Date: February 5, 2009
To: S505 Customers
Subject: S505 Product Change Notification

To continuously improve our products and processes, Cooper Bussmann has made some modifications to select ratings within the S505 fuse line.

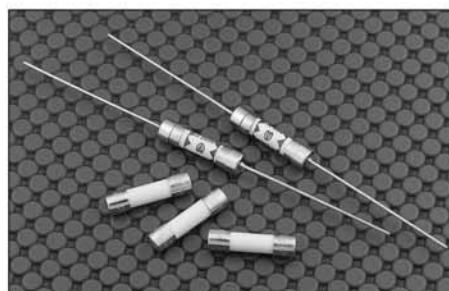
Fuse dimensions remain the same for all part numbers without axial leads. For fuses with axial leads (part numbers containing "-V"), some ratings will be fitted with larger diameter leads. Lead diameter for S505-V-4-R (all prefixes), and S505-V-5-R (all prefixes) has increased from 0.65mm to 0.81mm.
